G. & G. SURVEY	L. & A.	OCT 1 1927	Acc. No.
G. & G. SURVEY					
L. & A.					
OCT 1 1927					
Acc. No.					
State: Washington					
DESCRIPTIVE REPORT					
Topographic Hydrographic	Sheet No. 4657				
LOCALITY					
Puget Sound					
Everett					
1927					
CHIEF OF PARTY					
G. C. Jones

DESCRIPTIVE REPORT TO ACCOMPANY HYDROGRAPHIC SHEET
REGISTER No.....

Report on Hydrographic Sheet No. 4657

Report on Hydrographic Sheet No. 4657 (Additional Work 1928)

H. 4657

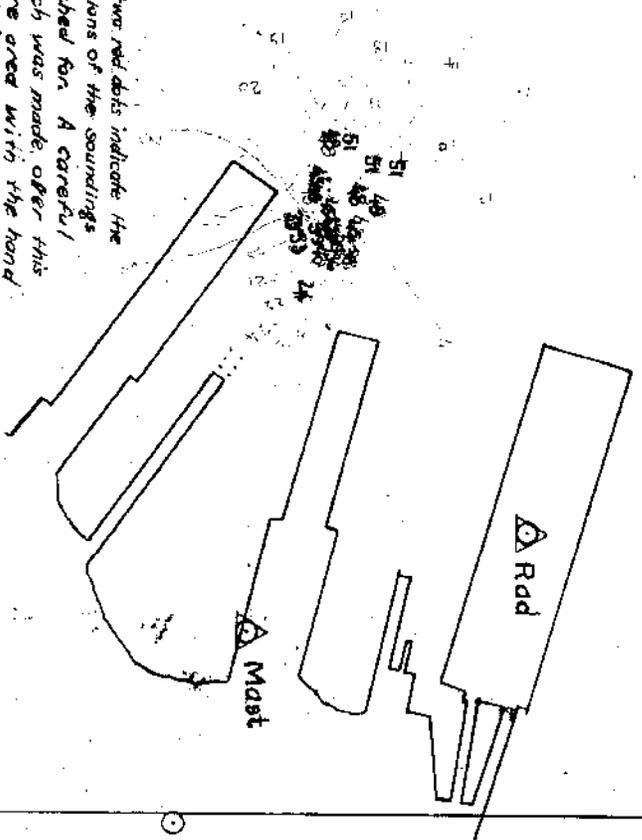
1. This examination was made to definitely disprove the existence of several shoal soundings off the docks at Everett Harbor, that were found on the first survey made in 1927 (H. 4657). The Chief of Party's explanation that on two of the positions (36 and 37 f), the wrong right object was used, seems to be borne out by the present examination. The 19 and 20 foot soundings on the first 1917 survey are well covered by depths of 39-42 foot soundings and there seems to be no question that these were erroneously located. The 27 foot sounding which was located about 40 meters to the westward of the above mentioned 19 does not appear to be as well covered on the present survey as the 19 and 20. This, however, may be due to the fact that only the shoalest soundings were located (see note on 1:5,000 scale tracing attached to this descriptive report). Furthermore, since the 19 and 20 foot soundings are proved to have been out of position, it necessarily follows that the 27 (pos. 36 f, first 1927 work) which controlled the location of the 19 and 20 was located in an erroneous position. It, too, should therefore be omitted. In accordance with the Chief of Party's statement in the descriptive report for H. 4657 (Ad. Work 1927) all the soundings that are dependent on positions 36 f and 37 f were rejected.

2. The work is shown in blue on the smooth sheet. As only a few soundings could be shown here, all the work was plotted on a 1:10,000 scale tracing and it is attached to the descriptive report. The original tracing (1:5,000 scale) on which the

The two red dots indicate the positions of the soundings searched for. A careful search was made over this entire area with the hand lead from a staff. Only the shallowest soundings were located.

Showing soundings made on April 20, 1928 according to the instructions of April 9, 1928 to supplement Sheet No 4657 of Everett Harbor.
